Environmental Review Team Report

Gray Lane Zone Change

Waterford, Connecticut

January 1982

Surficial Geology

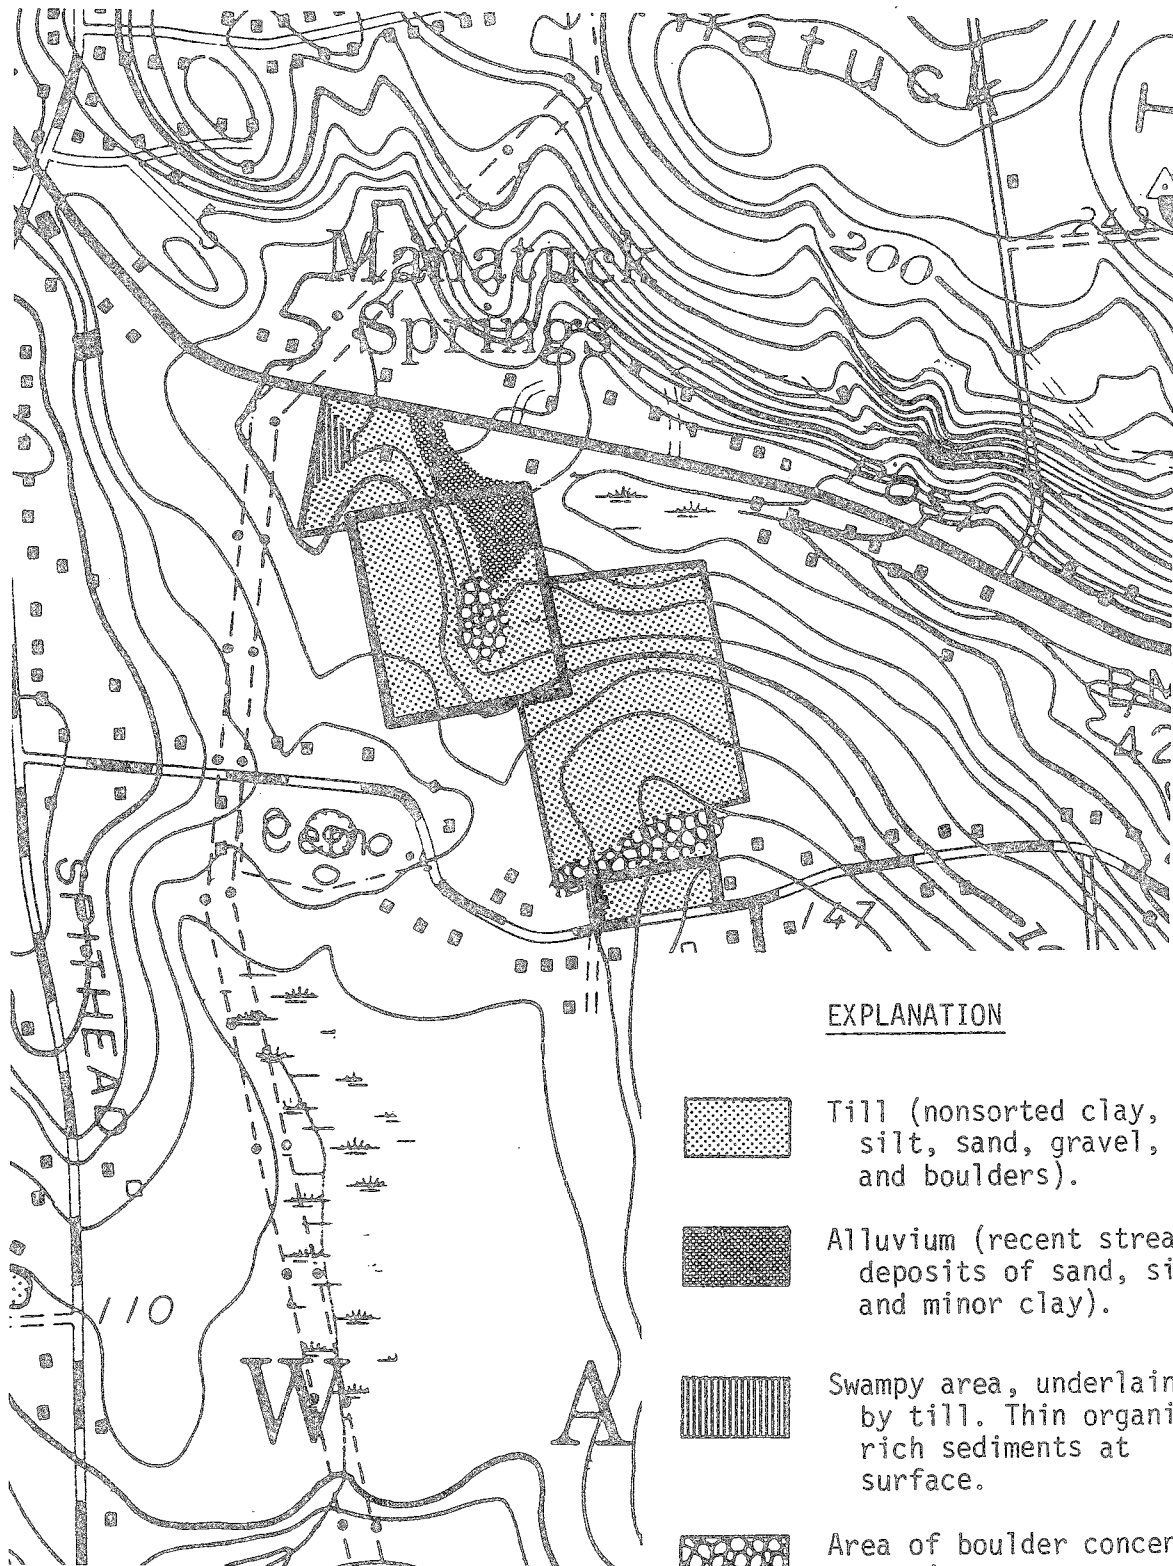
Till overlies virtually all of the property. Till is a glacial sediment consisting of a nonsorted mixture of clay, silt, sand, gravel, and boulders. A concentration of surface boulders exists in the southern section of the larger CMF zoned tract. This concentration suggested to Goldsmith that the till in this area was part of a discontinuous end moraine. An end moraine is a linear, hummocky deposit that forms at the end of a glacier (the ice front) when the glacier is neither advancing nor retreating for an extended period of time. Whether the till on this portion of the site is actually part of an end moraine will have little practical effect on the proposed development; the textural characteristics of till and the end moraines mapped by Goldsmith are similar. Typically, the upper few feet of the deposit will be sandy, stony, and loose, while deeper portions will be siltier, less stony, and compact. The texture of till is variable, though, so differences may be expected from place to place.

A second concentration of surface boulders is located along a stream-course near the southwestern corner of the larger R-40 zoned tract. In the northeastern corner, the parcel becomes flat and wet. Thin accumulations of stream-deposited sand, silt, and clay, mixed with minor to major percentages of organic material, overlie till in this area. The developers have proposed constructing a retention pond on this portion of the property.

The surficial geology of the parcel should pose no difficulties for the proposed development, especially since both public water and public sewerage will be available. At worst, the boulder concentrations may be a nuisance to move.

Vegetation

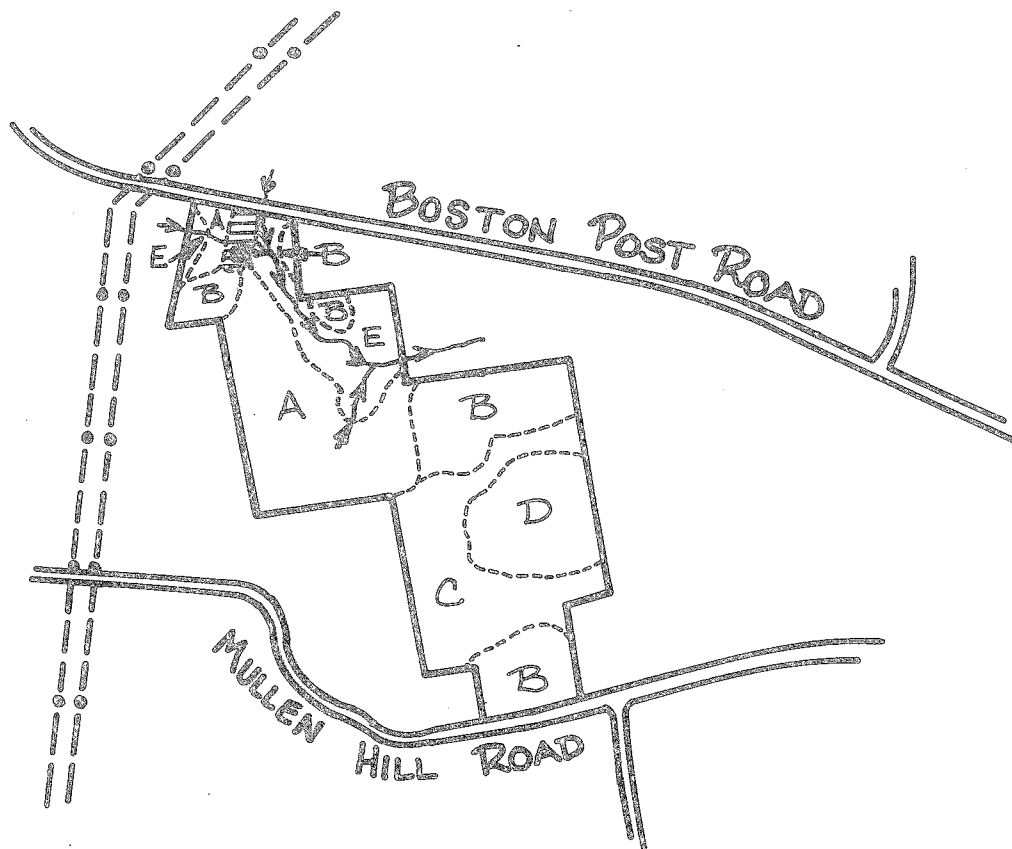
There are many trees within Vegetation Type A (Mixed Hardwoods) which are healthy and of high enough quality to be considered for retention for their

Several species of flowering trees and shrubs including flowering dogwood and mountain laurel are present in Vegetation Types A, B, and C. These flowering trees and shrubs have high aesthetic value and should be retained where feasible. The flowering of these trees and shrubs may be stimulated by allowing direct sunlight to reach them. This may be accomplished by complete or partial removal of the overstory trees which obstruct direct sunlight.

Windthrow is a potential hazard in the hardwood swamp areas (Vegetation Type E). The soils in these areas are saturated with water for the greater part of the year causing soil aeration to be poor. These conditions result in the development of shallow root systems which are unable to securely anchor trees. Clearings and openings which are made in or along side this area (such as clearing for the proposed retention pond) may accelerate the loss of neighboring trees to windthrow and should, therefore, be minimized or avoided. Ideally, clearing operations should also be avoided in a 30 to 50 foot wide buffer area surrounding the sensitive hardwood swamp areas.

Scattered throughout Vegetation Type A (Mixed Hardwoods) are large saw-timber size trees, some of which have large dead branches which could become a hazard if buildings, roadways, parking lots or utility lines are located near them. These trees should be pruned of their dead branches or completely removed to avoid this potential hazard.

The trees which are present in Vegetation Type A (Mixed Hardwoods) are rapidly declining in health and vigor as a result of their crowded condition. Under these conditions, the trees which are present are becoming more susceptible to further degradation by adverse weather condition, disease and insect infestation. Ideally this stand should receive a commercial improvement thinning. This harvest could remove approximately one-third of the trees from the overstory, focusing on the removal of the poorest quality trees. Such a thinning would reduce the competition between the residual higher quality trees for space, sunlight, nutrients and water. The remaining trees will overtime become more stable and improve in health and vigor.
